SERVICE BULLETIN

DATE: 05 MAY 1998
PAGE 1 OF 3

CYCLIC CONTROL MIXER LINKS REPLACEMENT (EIGHT DEGREE PHASE SHIFT RECOVERY)

Figure 1. Cyclic Control Mixer Links Replacement.

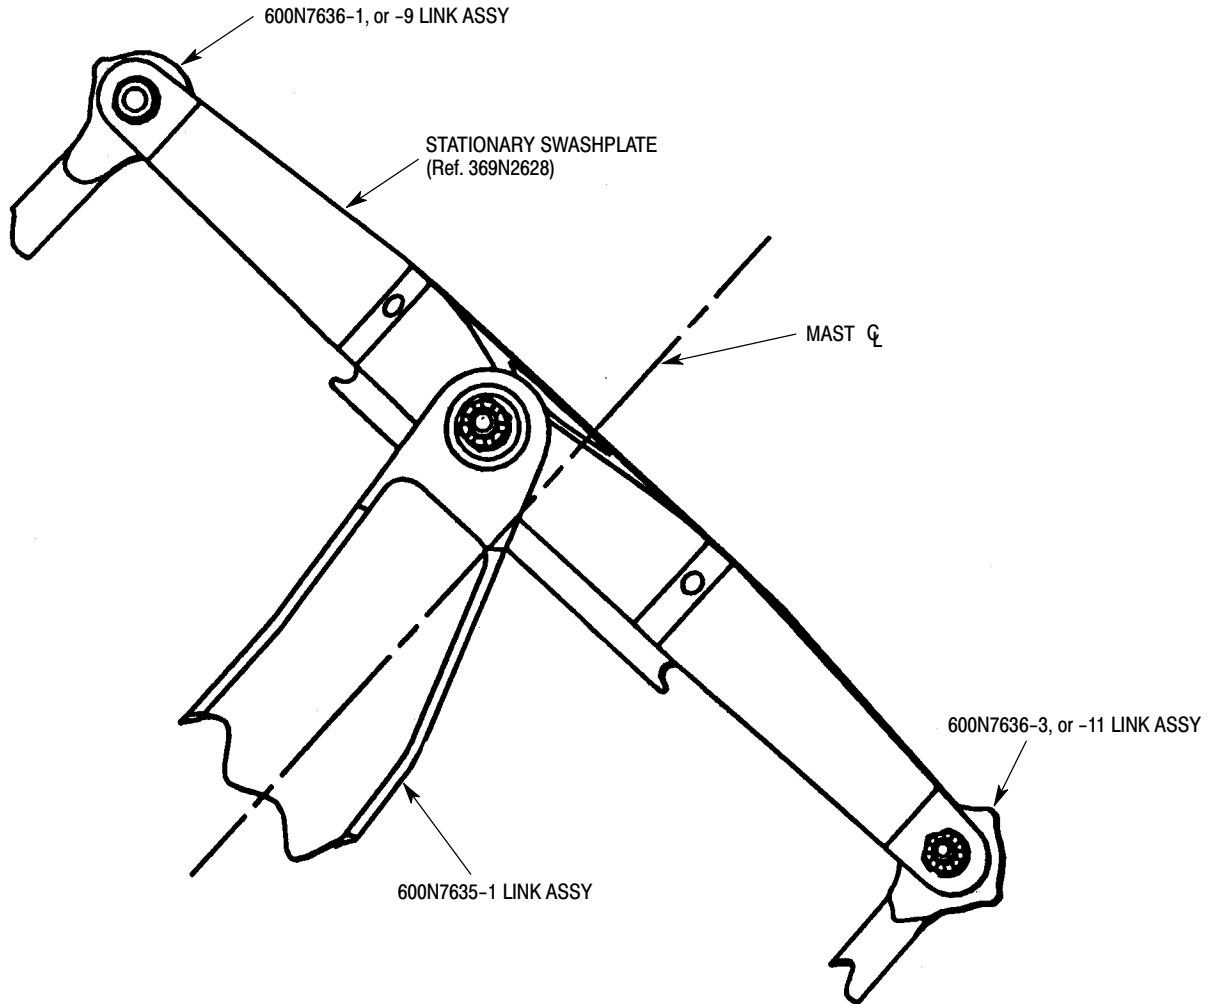
To recover the cyclic phase shift caused by adding the sixth blade to the main rotor system. Complying with the requirements of this Bulletin will result in reduced pilot workload.

Procedures in this Bulletin provide owners and operators with information pertaining to replacing various longitudinal and lateral mixer output links in the main rotor control system.

REPLACEMENT PARTS/SUPPLIES			
Nomenclature	Part No.	Qty.	Source
Link Assembly	600N7635-1	1	MDHS
Link Assembly	600N7636-1, or -9	1	MDHS
Link Assembly	600N7636-3, or -11	1	MDHS
